# UNITED STATES PATENT AND TRADEMARK OFFICE

APPLICATION NO.	FILING DATE	FIRST NAMED INVENTOR	ATTORNEY DOCKET NO.	CONFIRMATION NO.
10/757,974	01/15/2004	Jeno Tihanyi	1890-0033	4260
7590	01/09/2006		EXAMINER	
Maginot, Moore & Beck Bank One Tower 111 Monument Circle, Suite 3000 Indianapolis, IN 46204			NGUYEN, HIEP	
			ART UNIT	PAPER NUMBER
			2816

<b>Office Action Summary</b>	<b>Application No.</b>	<b>Applicant(s)</b>	
	10/757,974	TIHANYI, JENOE	
	Examiner Hiep Nguyen	Art Unit 2816

## **DETAILED ACTION**

Fig. 10

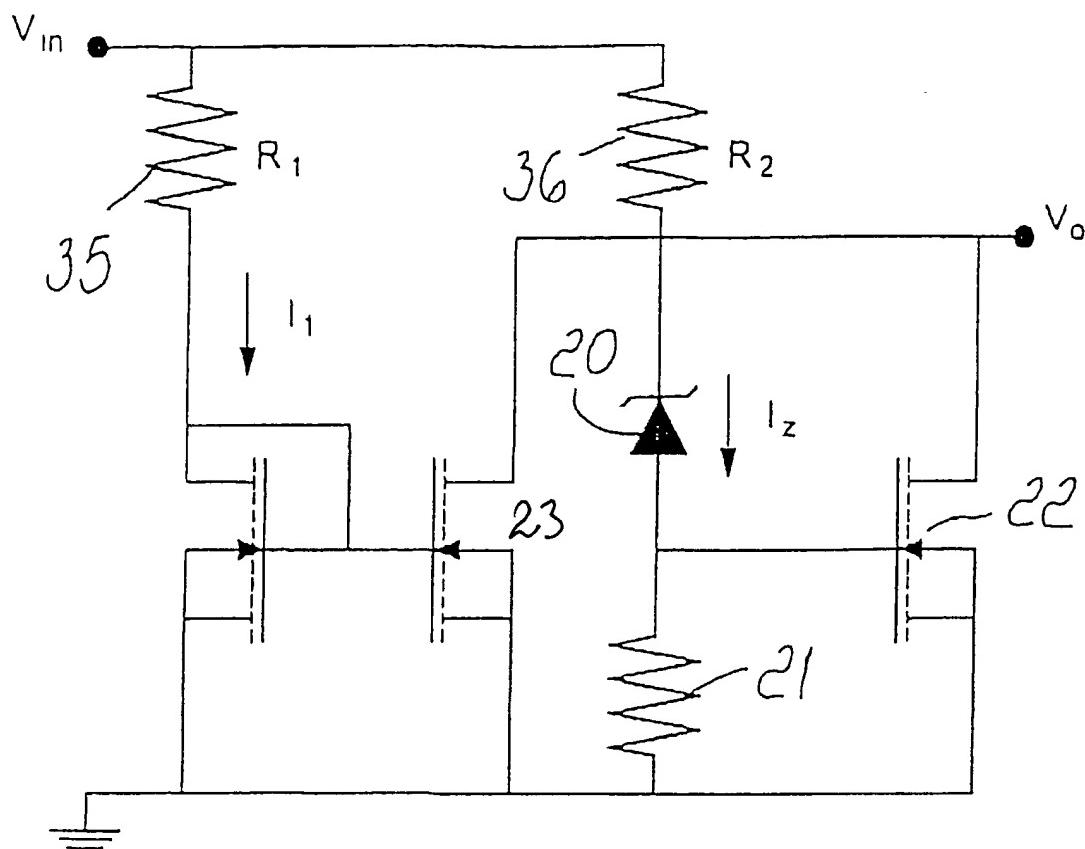
Regarding claim 15, figure 10 of Alessandria shows a MOSFET circuit comprising: a first MOS transistor (23), a second MOS transistor (22) connected in parallel, a Zener diode (20) coupled between the gates of the first and second MOS transistors. Figure 2 of Pavlin shows a MOSFET circuit comprising a first transistor (TP1) and a second transistor (TP2) wherein the second transistor has less cells than the first transistor (col. 3, lines 32-50). The circuit taught by Pavlin has lower threshold current than the circuit having two transistors having an equal number of cells (col. 4, lines 41-62). Therefore, it would have been obvious for one of ordinary skill in the art to replace transistors (22) and (23) of Alessandria with the transistors taught by Pavlin for lowering the threshold current.

Regarding claims 24, figure 10 of Alessandria shows a MOSFET circuit comprising: a first MOS transistor (23), a second transistor (22) coupled in parallel with the first MOS transistor, a constant voltage element is a Zener diode (20). Figure 10 of Alessandria does not show that the first MOS transistor has a first number of cells and the second MOS transistor has a second number of cells. Figure 2 of Pavlin shows a MOSFET circuit comprising first second MOS transistor (TP1) and second NMOS transistor (TP2) coupled in parallel. The second transistor (TP2) has a second number of cells less (10-40 times) than the first number of cells (col. 4, lines 35-40) for providing a circuit having low threshold current that is many times lower than the circuit of Alessandria wherein the transistors have an equal number of cells. (col. 4, lines 50-62). Therefore, it would have been obvious for one of ordinary skill in the art to replace the transistors of Alessandria with the transistors taught by Pavlin for providing a circuit having low threshold current that is many times lower than circuit wherein the transistors have an equal number of cells. The resistor is element (R2).

Regarding claims 30, figure 10 of Alessandria shows a MOSFET circuit comprising: a first MOS transistor (23), a second transistor (22) coupled in parallel with the first MOS transistor, a constant voltage element is a zener diode. Figure 3 of Alessandria does not show
